Subject: NMED's Request for Additional Information, Los Alamos National Laboratory's
 Ground Water Discharge Plan Application, Radioactive Liquid Waste
 Treatment Facility (TA-50), DP-1132

**Radioactive Liquid Waste Treatment Facility
Ground Water Discharge Plan Application
Request for Additional Information**

Fig. VIII-L. Mortandad Canyon observation well MCO-4B, completed August 1990, water level 21.7 ft (Purtymun and Stoker 1990).

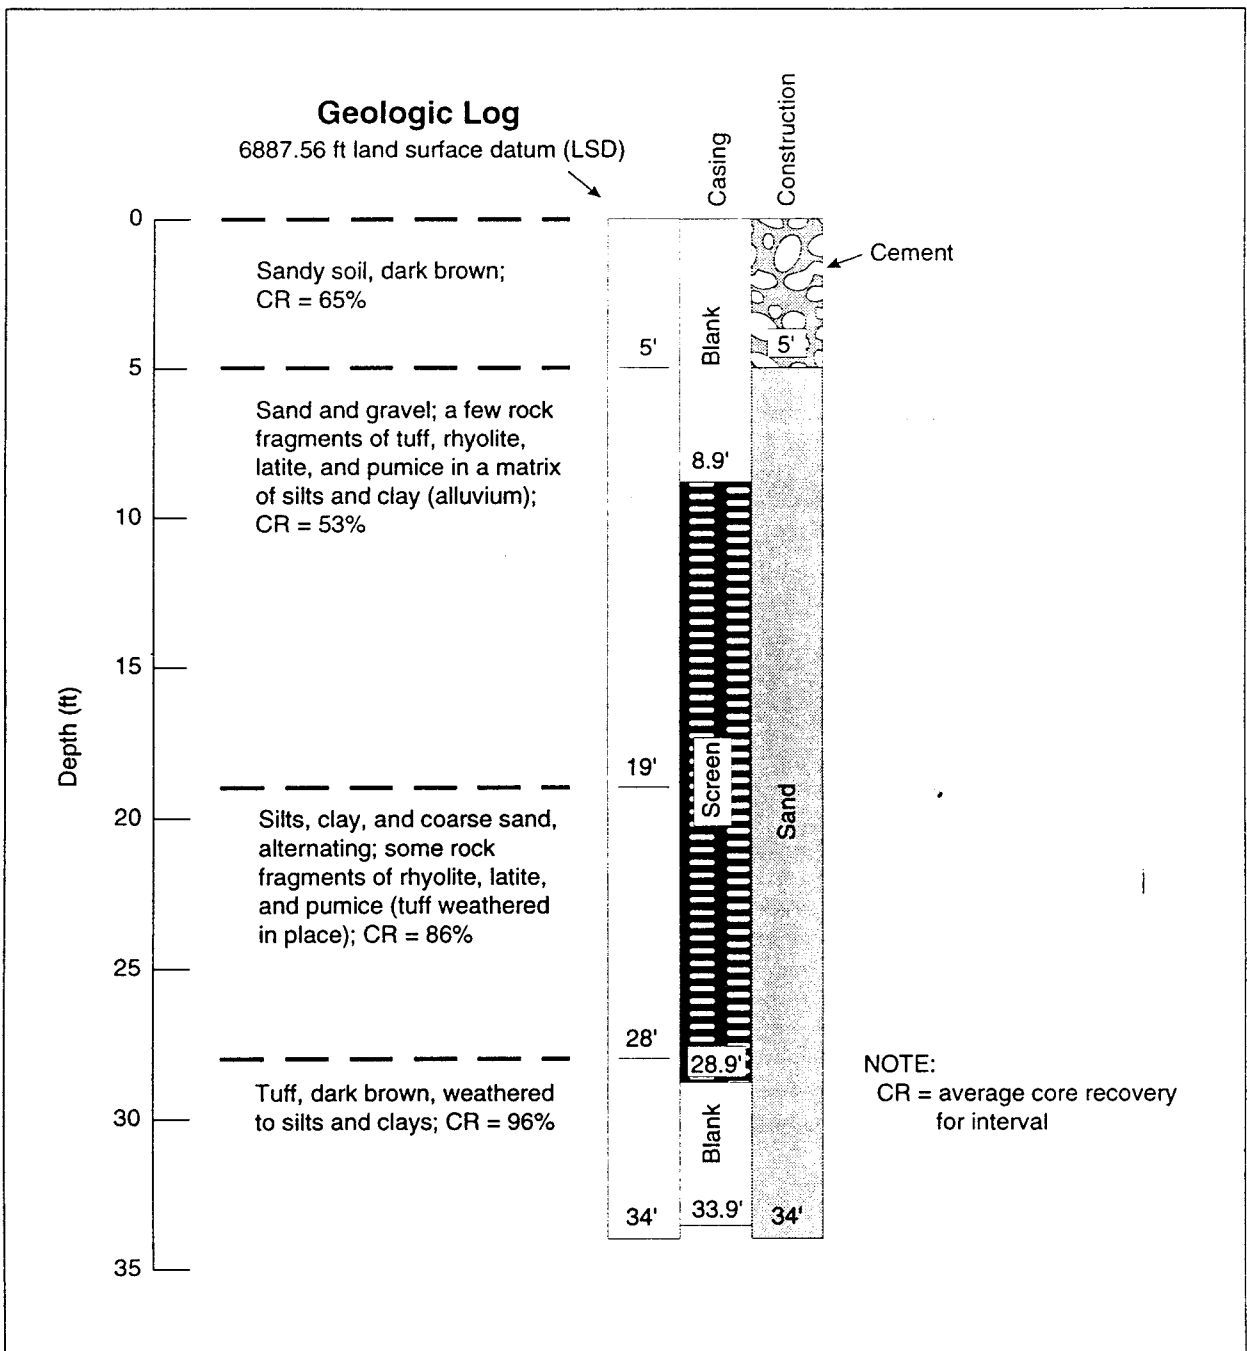
- 5) **NMED Comment.** *The system of monitor wells in Mortandad Canyon is not adequate to monitor ground water quality as required by the WQCC Regulations.*
- a. *Please commit to repairing MCO-3.*
 - b. *Please commit to repairing MCO-4.*
 - c. *Please commit to quarterly sampling and analysis of a ground water sample from a monitor well completed in the main aquifer. Please propose, for GWQB approval, a monitor well for routine monitoring of the main aquifer.*
 - d. *The table does not provide information on the screened section for each of the proposed monitor wells.*

- b. MCO-4 will not be repaired. MCO-4B will replace MCO-4 as a monitoring well for the Ground Water Discharge Plan Application. Geologic log and well construction data for MCO-4B have been provided in Attachment 2.
